# Sumter City-County Planning Commission

## MSP-15-29 City Parking Garage (S. Sumter St. and Hampton.)

### I. THE REQUEST

# Site Plan

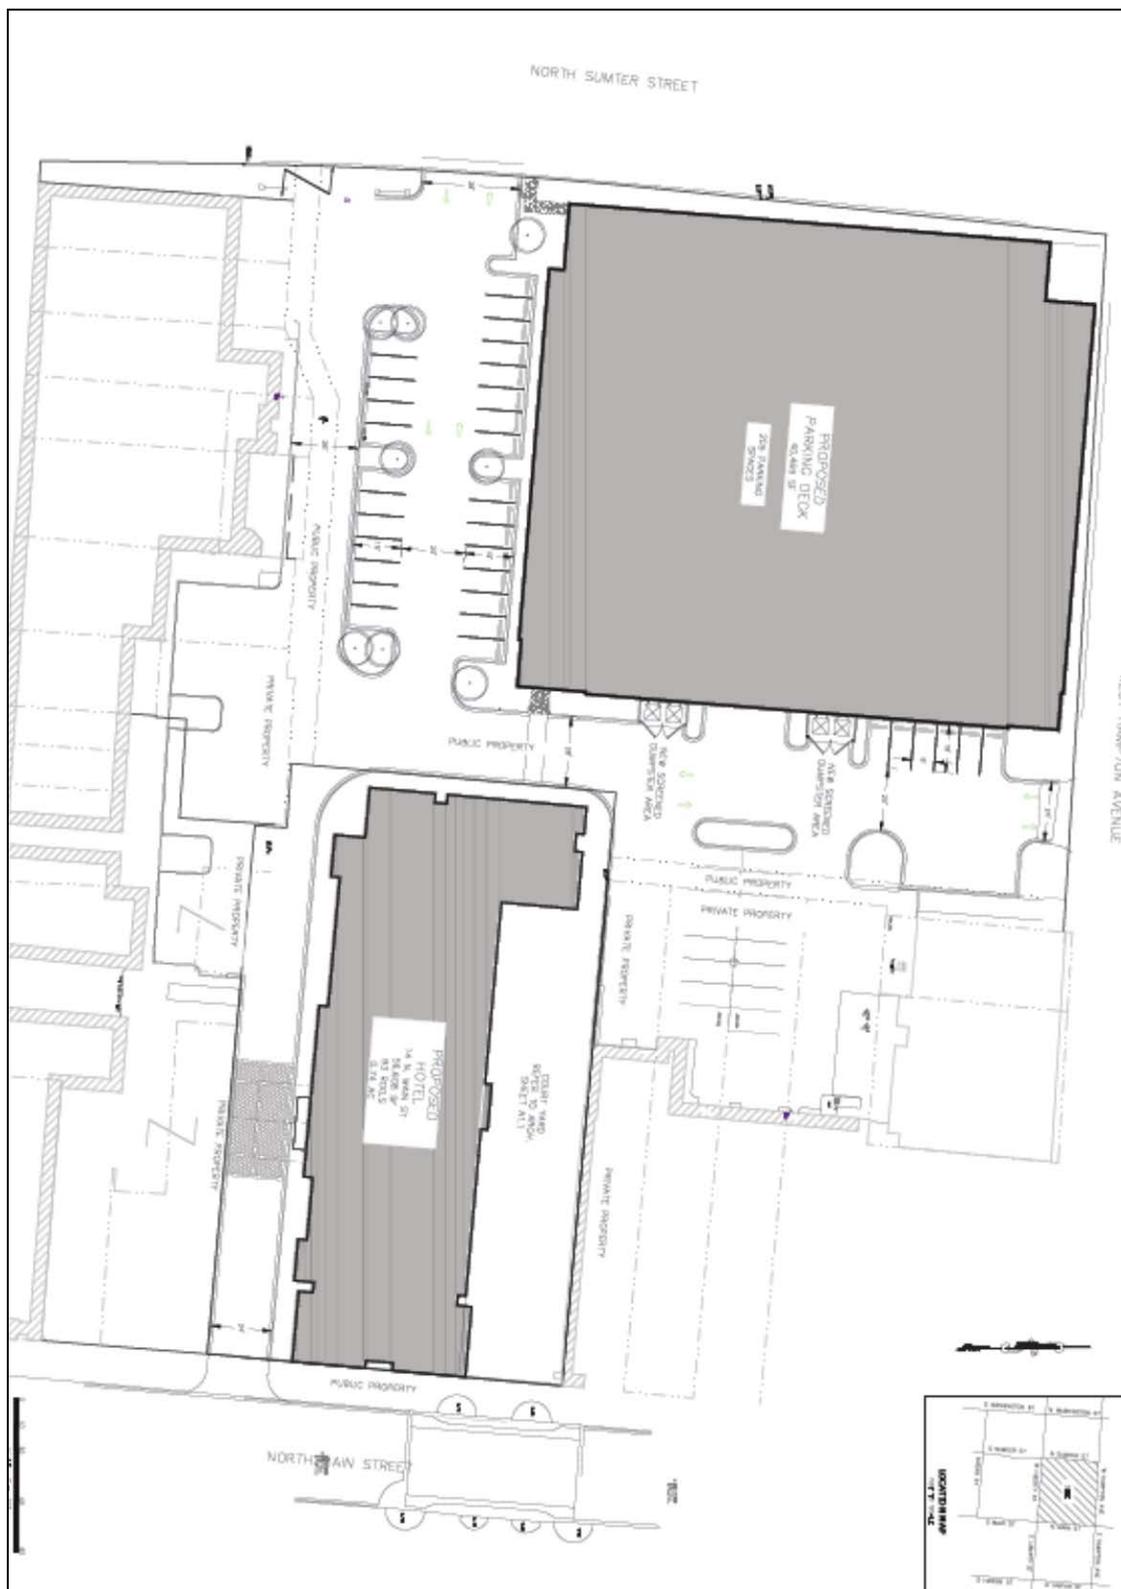
Based upon the submitted plans, the proposed development meets these minimum setback standards.

Building projects in the CBD do not typically require landscaping. However, parking lots and parking garages do require perimeter landscaping. This landscaping exists today on the perimeter of the existing surface lot along with a wrought iron fence connected by brick

monuments. The brick and wrought iron fence element will be removed the landscaping will remain. Any landscaping damaged by the construction will be replaced.

The garage will be constructed over a portion of the existing surface lot and will access the local street network using existing points on S. Sumter St. and Hampton Ave. The vehicles will enter and exit the garage via the internal access shown on the plan. A 34 space surface lot section, will also remain.
